Product Change Notification

Business Unit	Product Line Code	Type of Change	Action	Date of Issue
AI - Automation Infrastructure	DNA	Product Change Notification	Notify Distributors and Field	1/18/2023

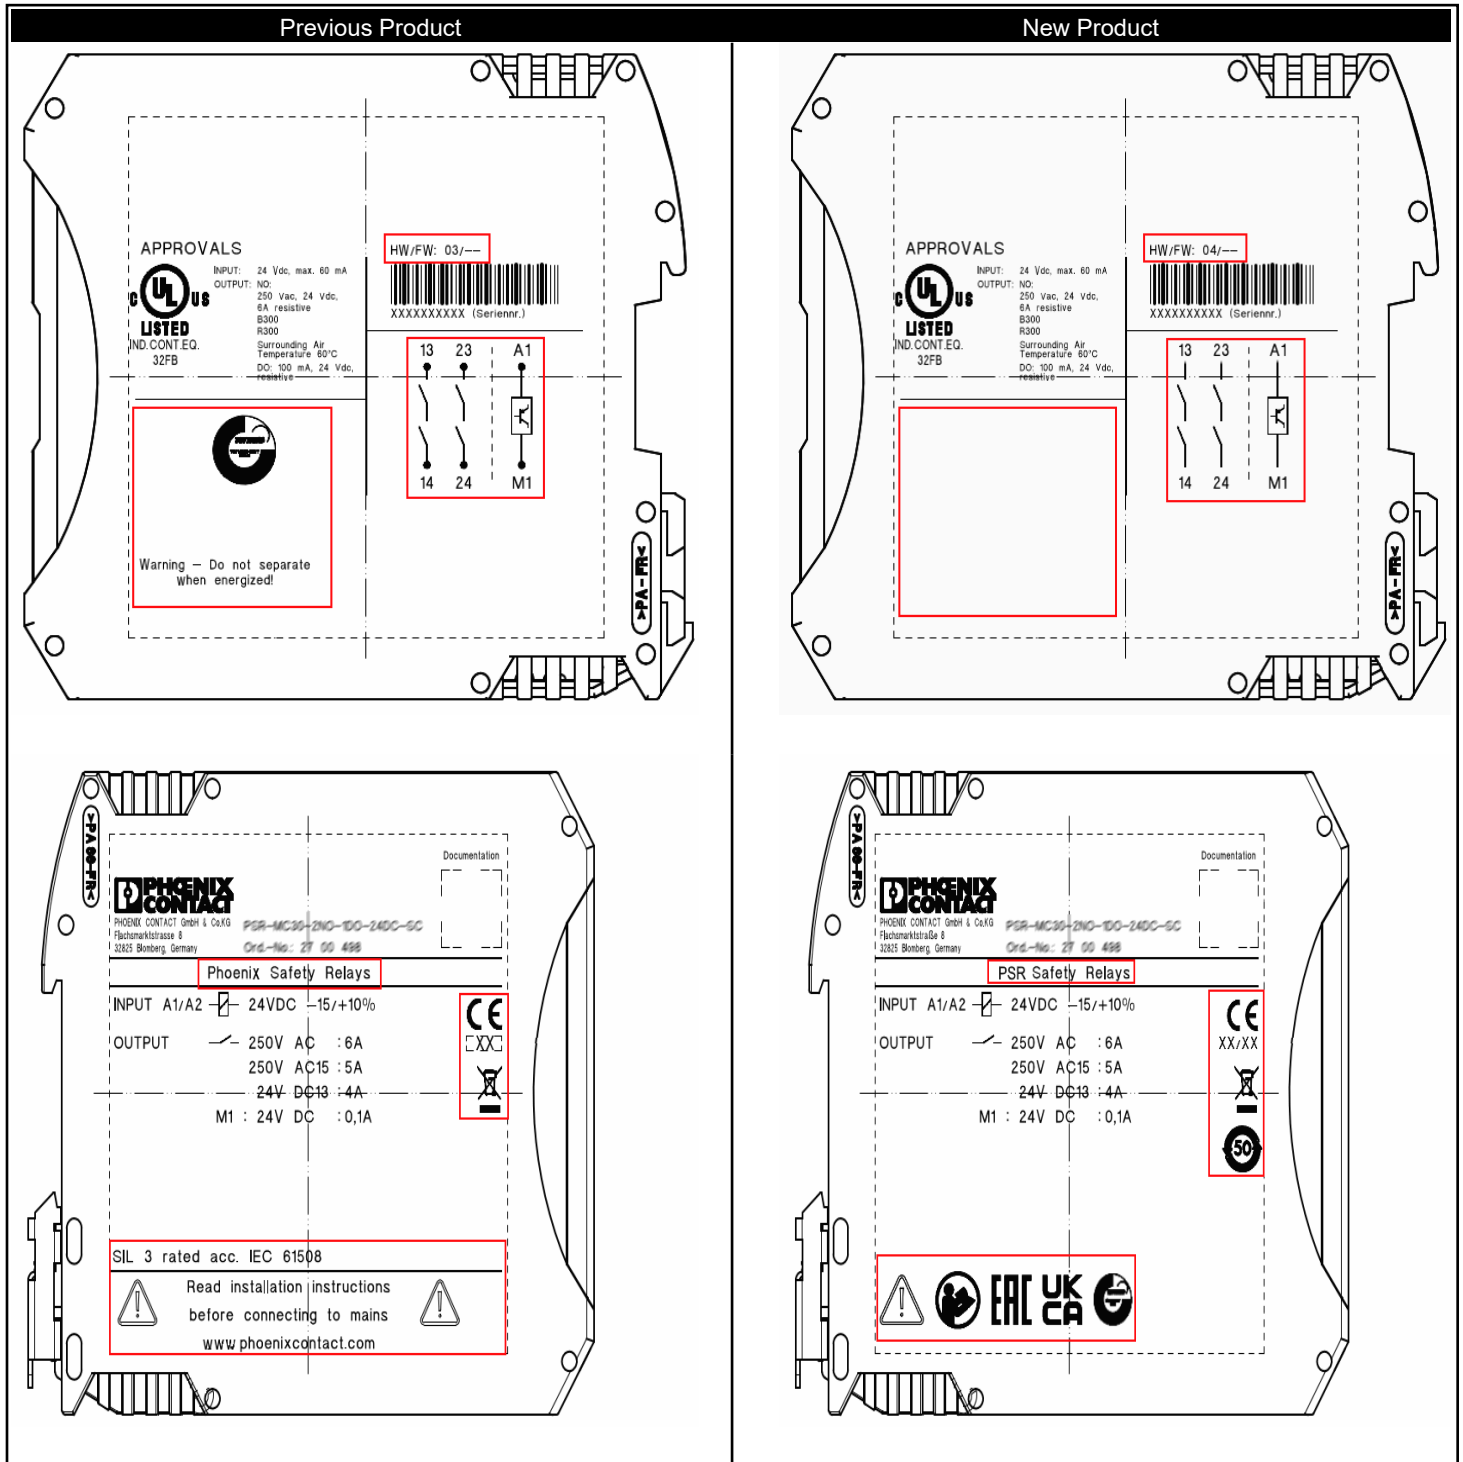
In addition to the year of manufacture, the calendar week will be displayed below the CE mark. Furthermore, the marking on the front of the housing will be changed and the various pictograms / approvals will now be displayed in the lower area on the left half of the housing. The terminal blocks will no longer be coded and the color of the terminal blocks will change from green to light gray (RAL 7035).
